Appendices

Appendix C: Facility Reports for City Buildings and Parks

Appendix D: Facility Reports for Downtown Parking Lots

Appendix E: Public Rights-of-Way Reports for City Facilities and Schools

Downtown Parking Lot 5 - PROW
Main Street at State Street
Los Altos, CA

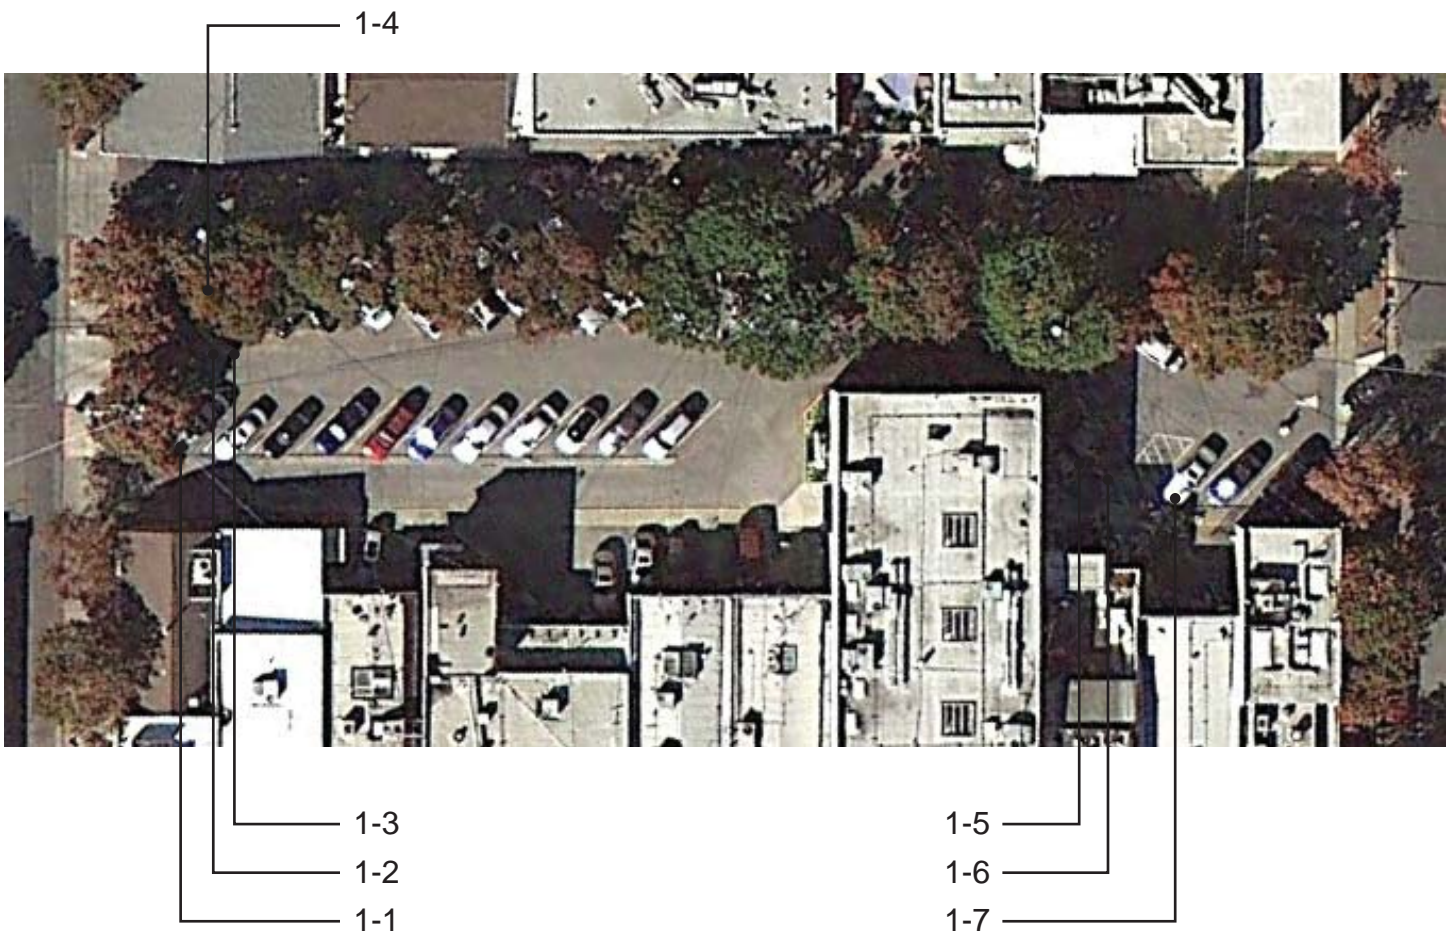
3 - 1	Curb Ramp	Priority: 1
Provide detectable warning strip		\$1,000
Notes: Truncated dome plate is 24" wide (36" min.).		
State: 1127B.5.7, IR11B-4		
Federal: -		
Provide level landing		\$5,000
Notes: Level landing at top is sloped at 2.8% (2% max.).		
State: 1127B.5.4		
Federal: -		
Provide surface texturing		\$1,000
Notes: No grooved border provided.		
State: 1127B.5.6		
Federal: -

Civic Center Campus - PROW
One North San Antonio Road
Los Altos, CA

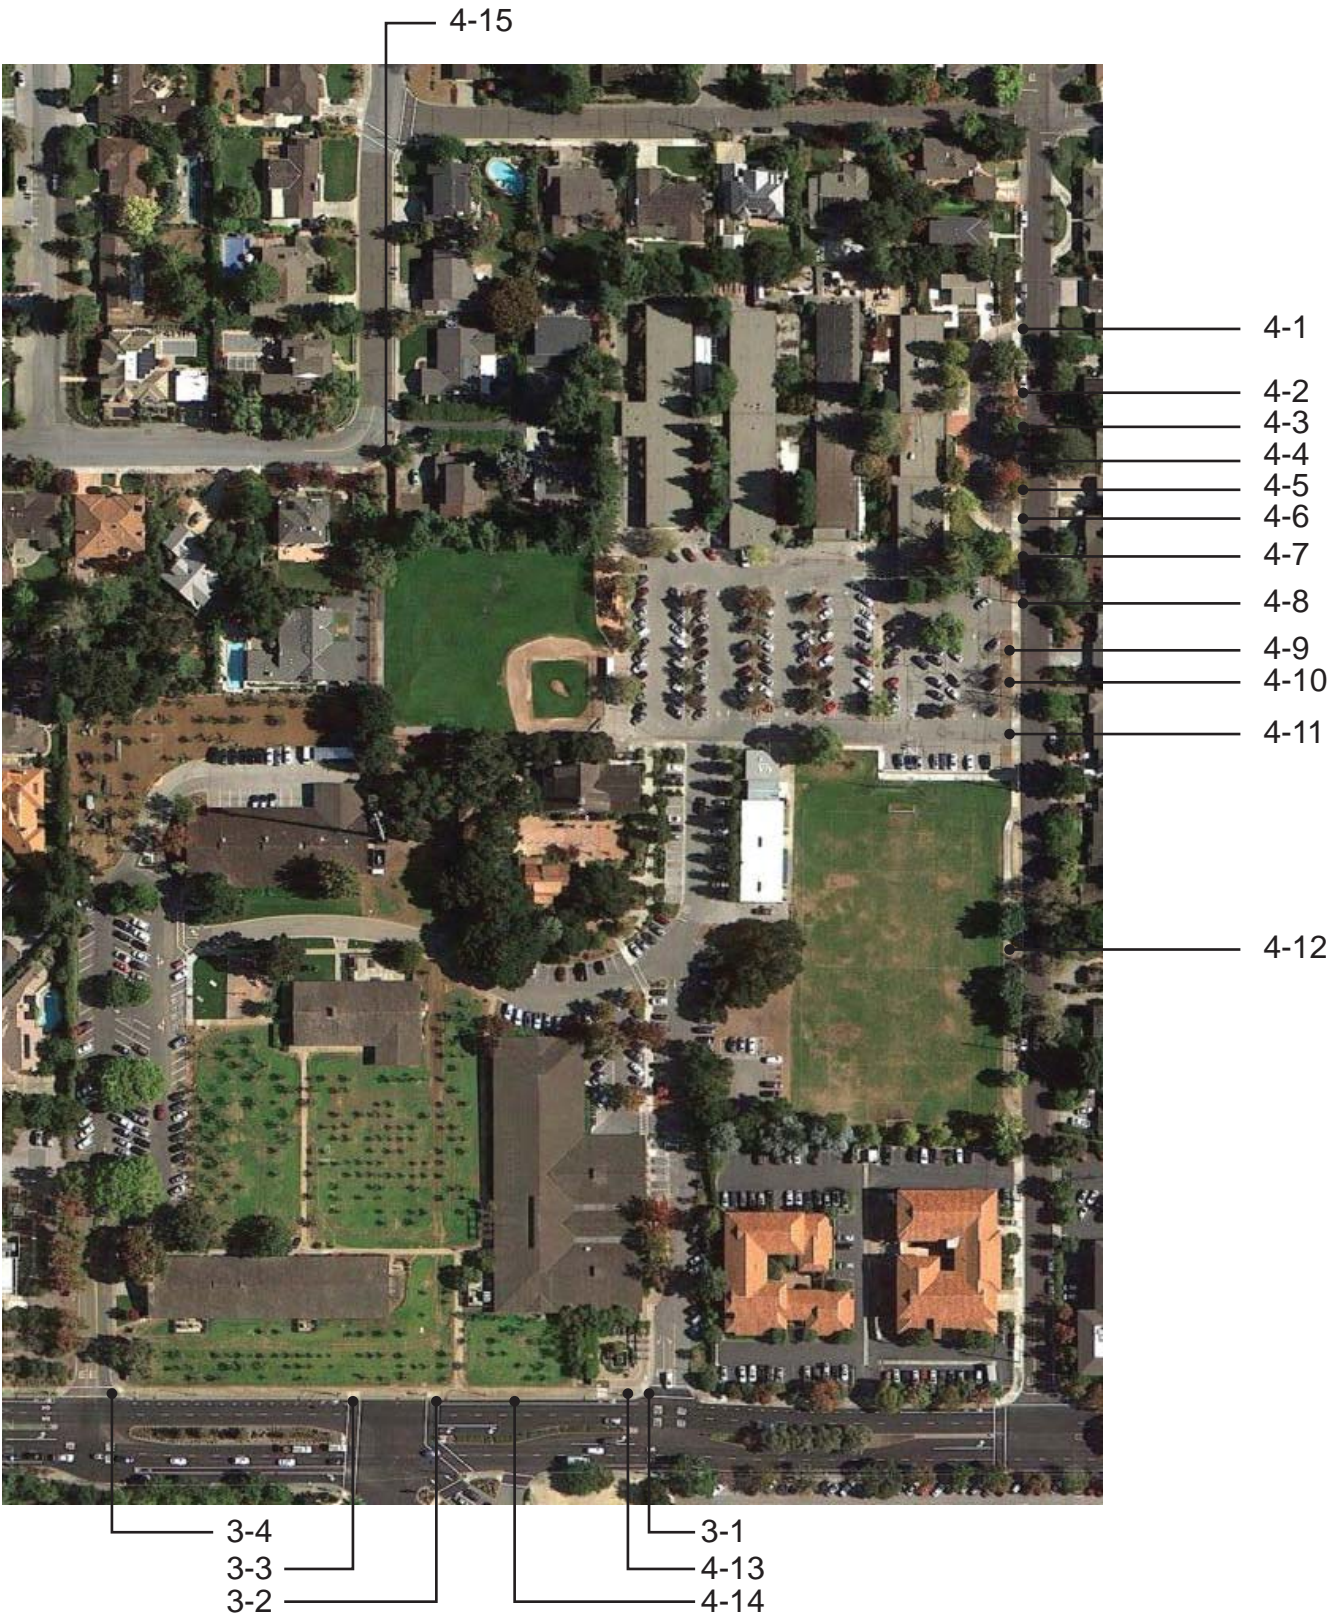
3 - 1	Curb Ramp	Priority: 1
Install, replace or modify curb ramp		\$3,500
Notes: Running slope is 14.2% (8.33% max).		
State: 1127B.5.3		
Federal: 405.2		
Provide level landing		\$5,000
Notes: Level landing at top is sloped at 3.7% (2% max.). Slope at gutter pan is 6.0% (5% max.)		
State: 1127B.5.3, 1127B.5.4		
Federal: 406.2		
3 - 2	Curb Ramp	Priority: 1
Provide detectable warning strip		\$1,000
Notes: Detectable warning pad is 24" of the length of the walking surface (36" required).		
State: 1127B.5.7, IR11B-4		
Federal: -		
Provide surface texturing		\$1,000
Notes: No grooved border provided.		
State: 1127B.5.6		
Federal: -

Lincoln Park - PROW
University and Lincoln Avenues
Los Altos, CA

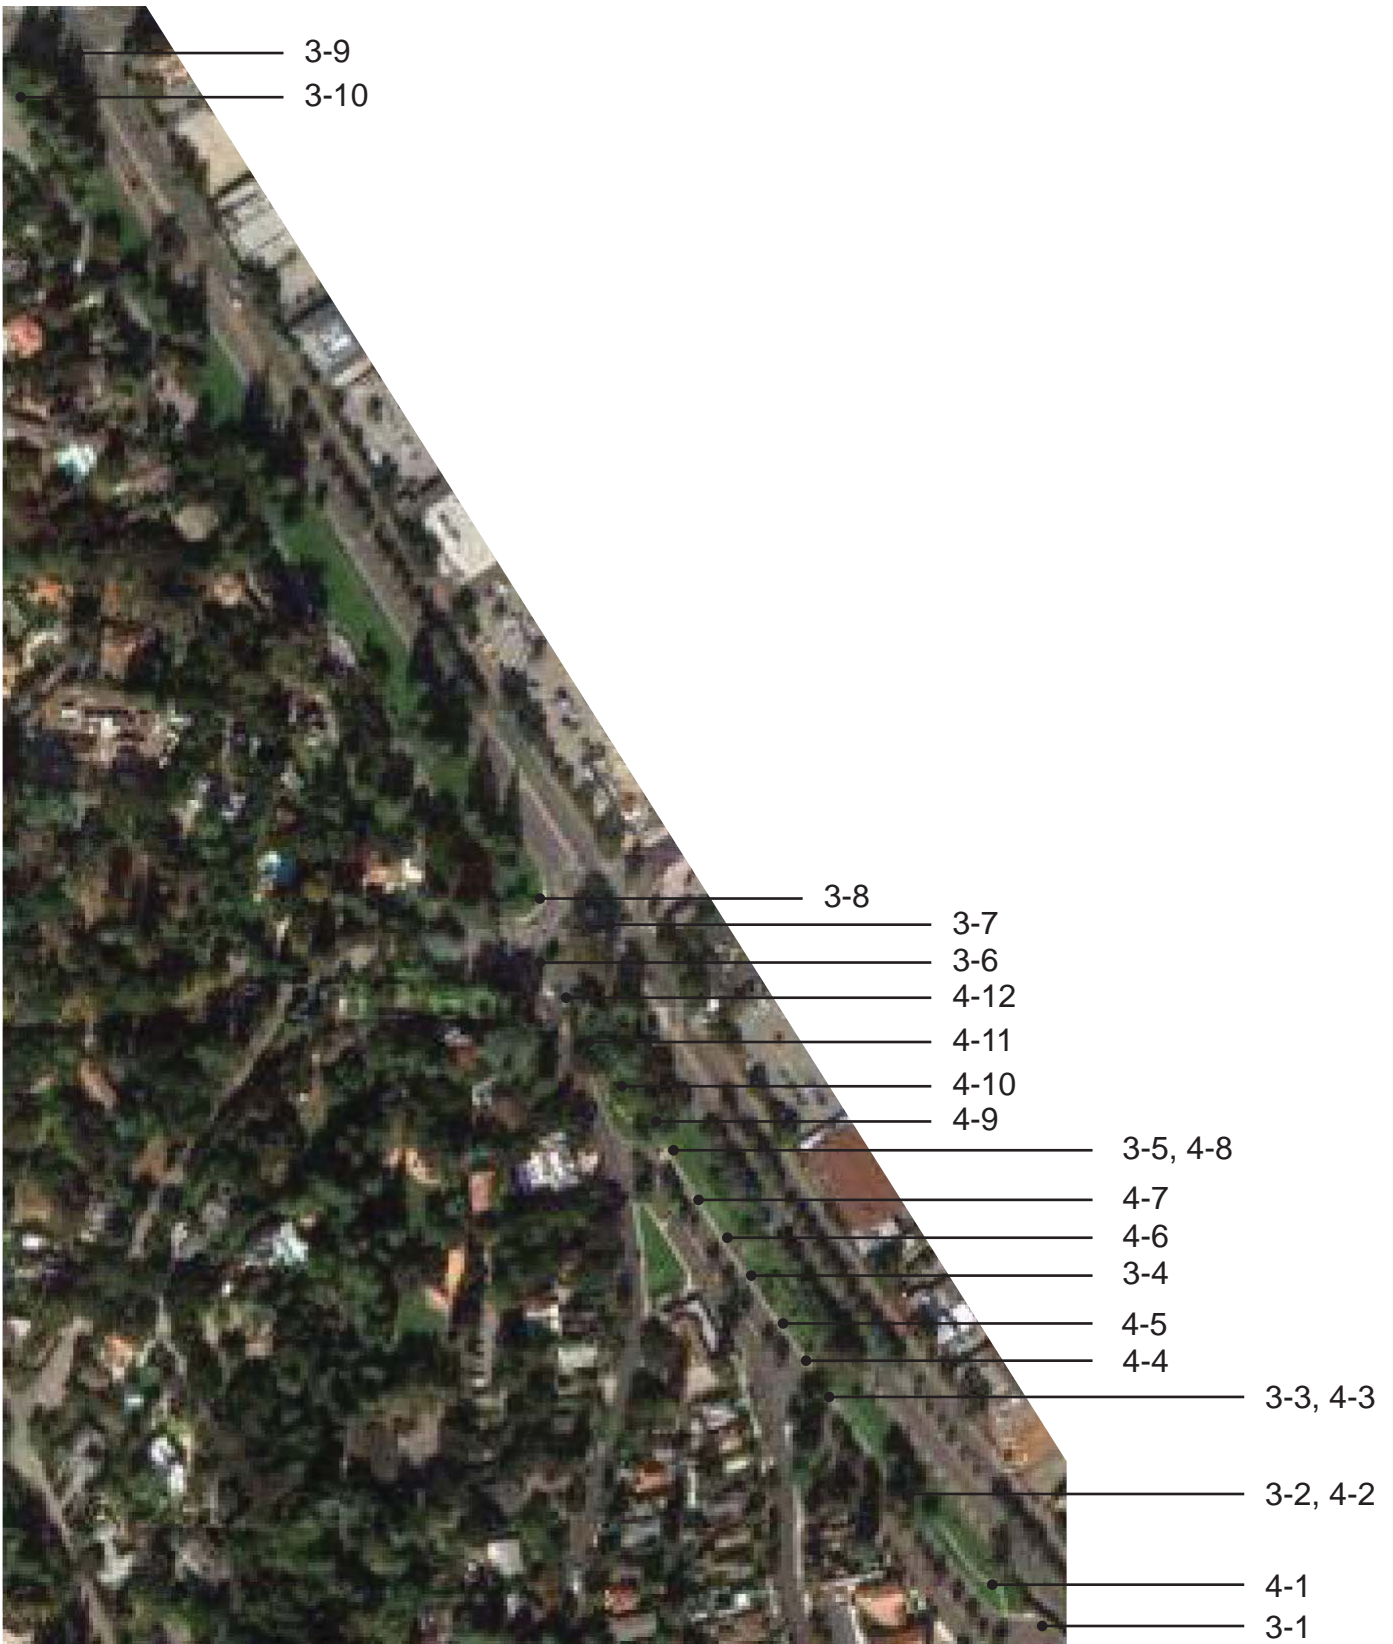
3 - 5	Curb Ramp	Priority: 1
Provide detectable warning strip		\$1,000
Notes: Detectable warning plate is 24" wide (36" min.).		
State: 1127B.5.7, IR11B-4		
Federal: -		
Provide level landing		\$5,000
Notes: Slope at gutter pan is 9.8% (5% max.)		
State: 1127B.5.3		
Federal: 406.2		
3 - 6	Curb Ramp	Priority: 1
Provide detectable warning strip		\$1,000
Notes: No detectable warning provided.		
State: 1127B.5.7, IR11B-4		
Federal: -		
Install, replace or modify curb ramp		\$3,500
Notes: Parallel curb ramp slope is 9.8% (8.33% max.).		
State: 1127B.5.3		
Federal: 405.2		
3 - 7	Curb Ramp	Priority: 1
Provide detectable warning strip		\$1,000
Notes: No detectable warning provided.		
State: 1127B.5.7, IR11B-4		
Federal: -		
Install, replace or modify curb ramp		\$3,500
Notes: Parallel curb ramp slopes are 10.2% and 8.8% (8.33% max.).		
State: 1127B.5.3		
Federal: 405.2

4 - 8	Walk	Priority: 1	
Regrade surface			\$800
Notes: Cross slope ranges from 2.1%-2.8% for 8 lf.			
State: 1133B.7.1.3			
Federal: 403.3			
4 - 9	Walk	Priority: 1	
Regrade surface			\$3,500
Notes: Cross slope ranges from 2.1%-4.8% for 35 lf.			
State: 1133B.7.1.3			
Federal: 403.3			
4 - 10	Walk	Priority: 1	
Regrade surface			\$3,500
Notes: Cross slope ranges from 2.1%-3.0% for 35 lf.			
State: 1133B.7.1.3			
Federal: 403.3			
4 - 11	Walk	Priority: 1	
Regrade surface			\$7,000
Notes: Cross slope ranges from 2.1%-4.0% for 70 lf.			
State: 1133B.7.1.3			
Federal: 403.3			
4 - 12	Walk	Priority: 1	
Regrade surface			\$2,500
Notes: Cross slope at driveway is 8.4% for 25 lf.			
State: 1133B.7.1.3			
Federal: 403.3

Woodland Library - PROW
1975 Grant Road
Los Altos, CA

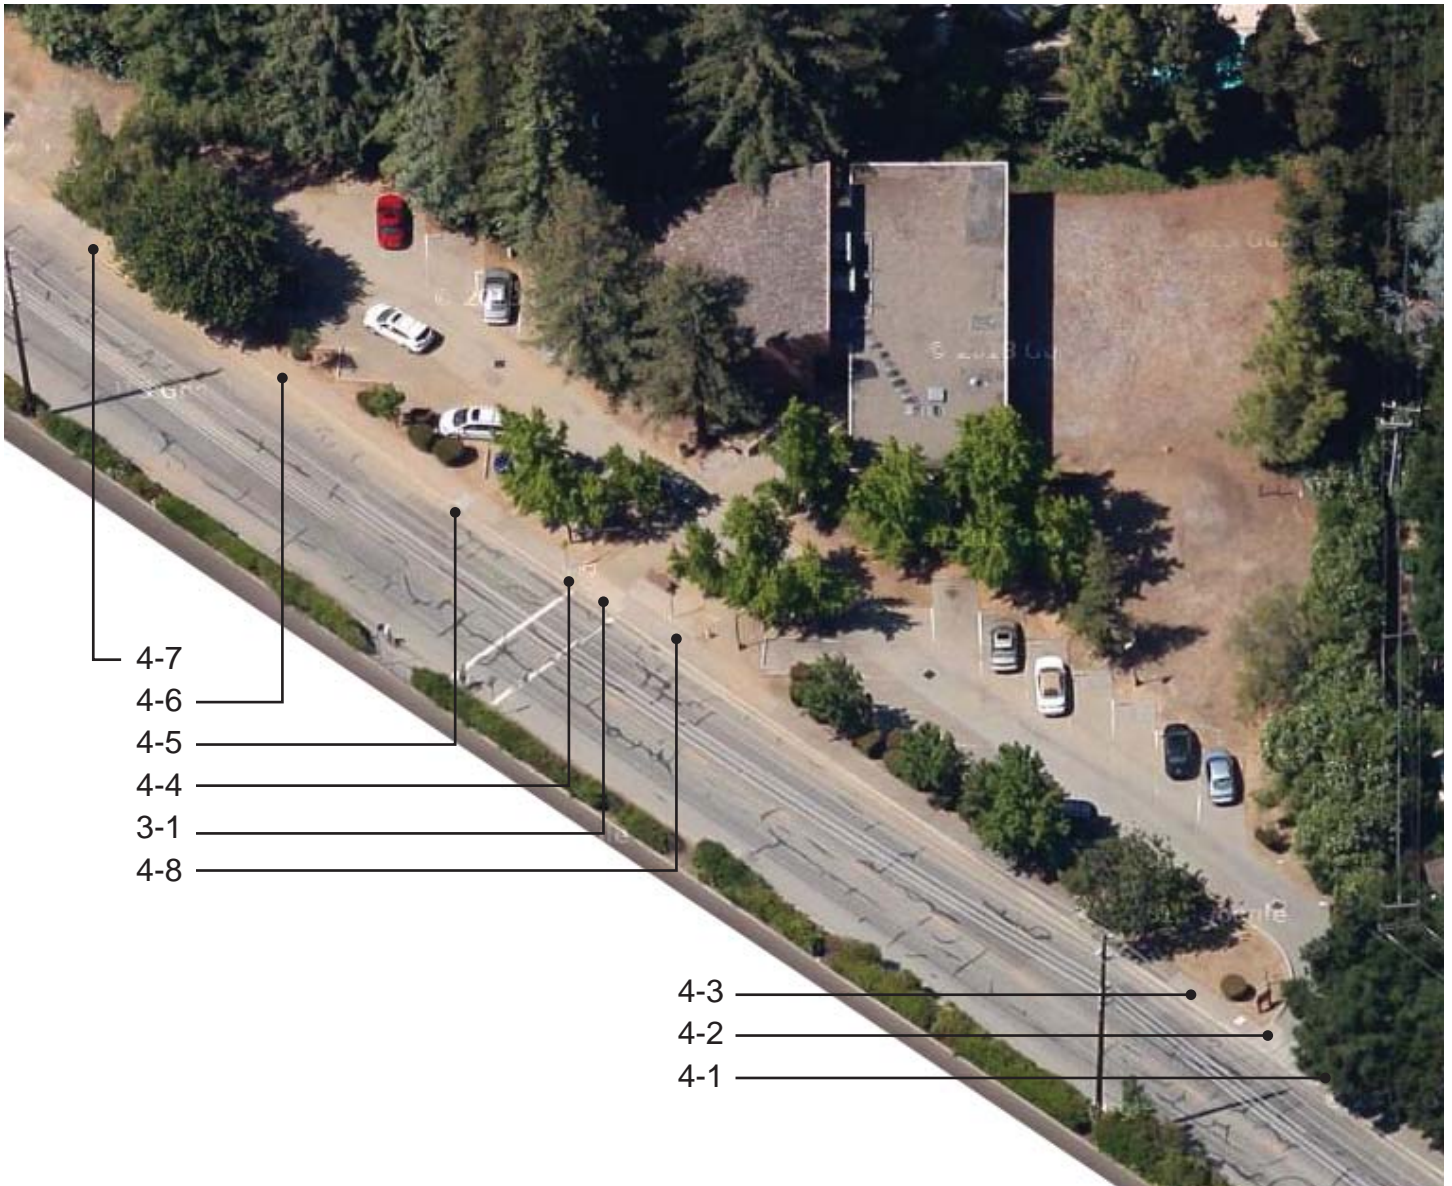
4 - 2	Walk	Priority: 1
Regrade surface		\$3,700
Notes: 2.1%-2.7% cs for 37 lf (2.0% max.).		
State: 1133B.7.1.3		
Federal: 403.3		
4 - 3	Walk	Priority: 1
Regrade surface		\$2,400
Notes: 2.1%-2.7% cs for 24 sf at new flag (2.0% max.).		
State: 1133B.7.1.3		
Federal: 403.3		
4 - 4	Walk	Priority: 1
Regrade surface		\$3,200
Notes: 2.1%-2.9% cs for 32 sf (2.0% max.).		
State: 1133B.7.1.3		
Federal: 403.3

Egan Junior High - PROW
100 W Portola Avenue
Los Altos, CA

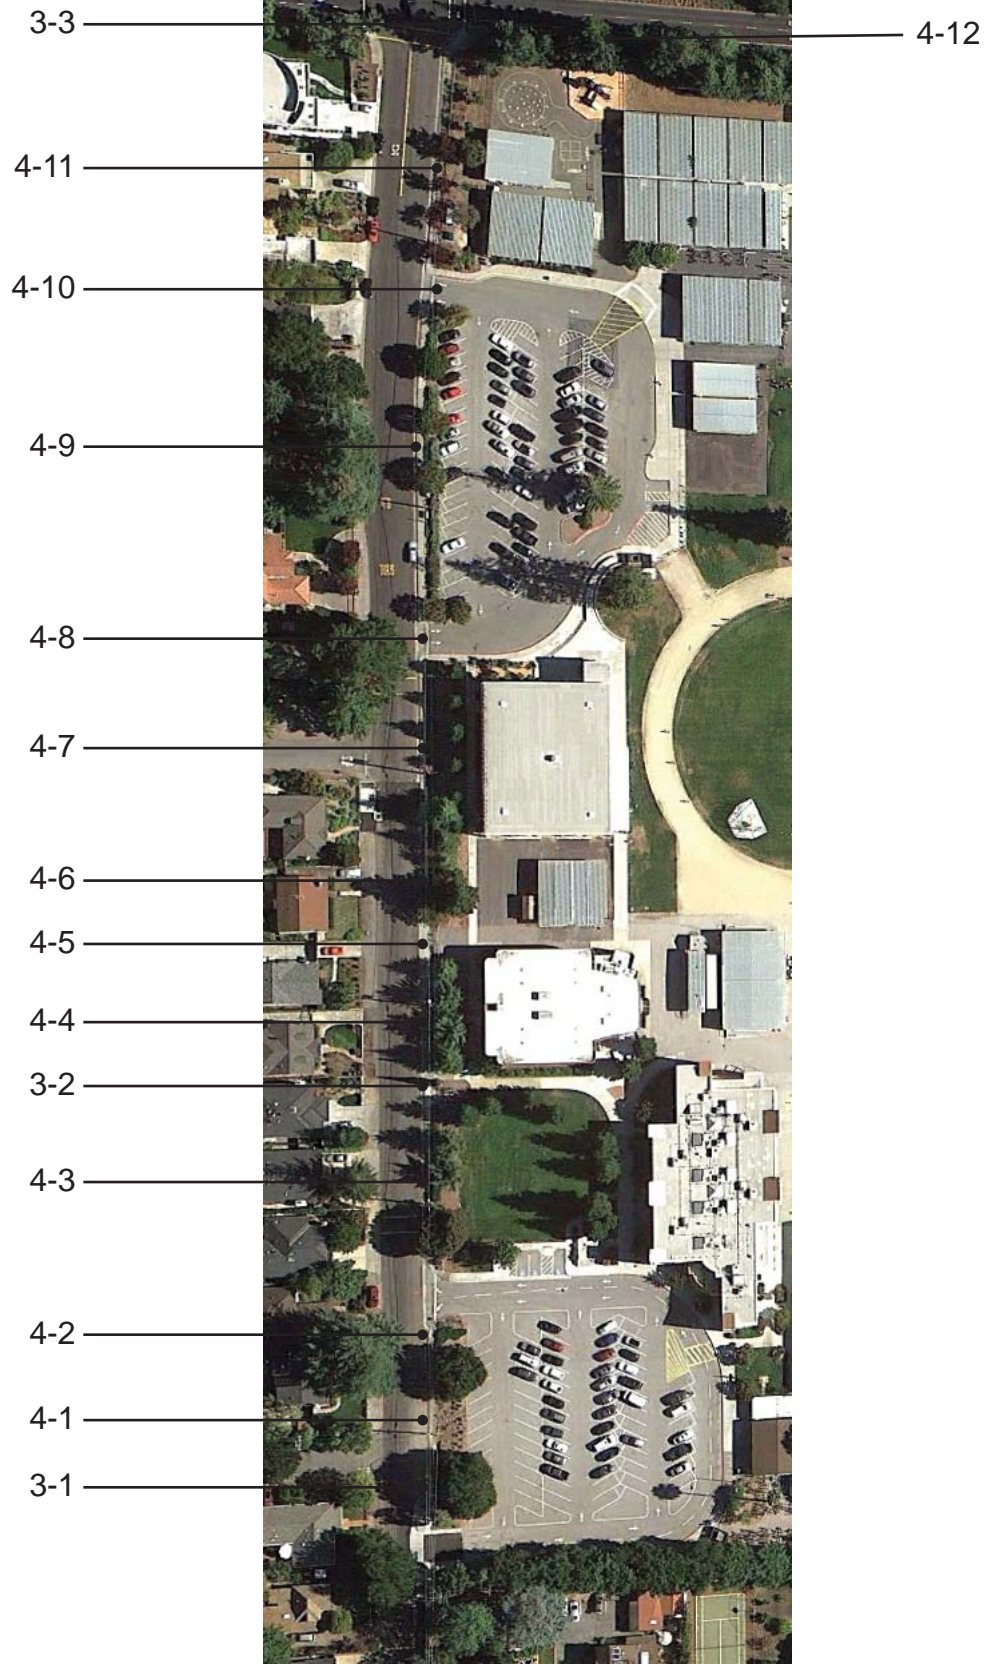
3 - 1	Curb Ramp	Priority: 1
Provide detectable warning strip		\$1,000
Notes: Detectable warning plate is 24" deep (36" required).		
State: 1127B.5.7, IR11B-4		
Federal: -		
4 - 1	Walk	Priority: 1
Regrade surface		\$2,500
Notes: 2.1%-3.3% cs (5.4% at drain) for 25 lf (2.0% max.).		
State: 1133B.7.1.3		
Federal: 403.3		
4 - 2	Walk	Priority: 1
Regrade surface		\$10,000
Notes: 2.1%-6.8% cs 100 sf at tree root/drive entrance (2.0% max.).		
State: 1133B.7.1.3		
Federal: 403.3		
4 - 3	Walk	Priority: 1
Regrade surface		\$1,500
Notes: 2.1%-4.6% cs for 15 lf at drain (2.0% max.).		
State: 1133B.7.1.3		
Federal: 403.3

4 - 4	Walk	Priority: 1
Regrade surface		\$1,800
Notes: 2.1%-2.7% cs for 18 lf at drive (2.0% max.).		
State: 1133B.7.1.3		
Federal: 403.3
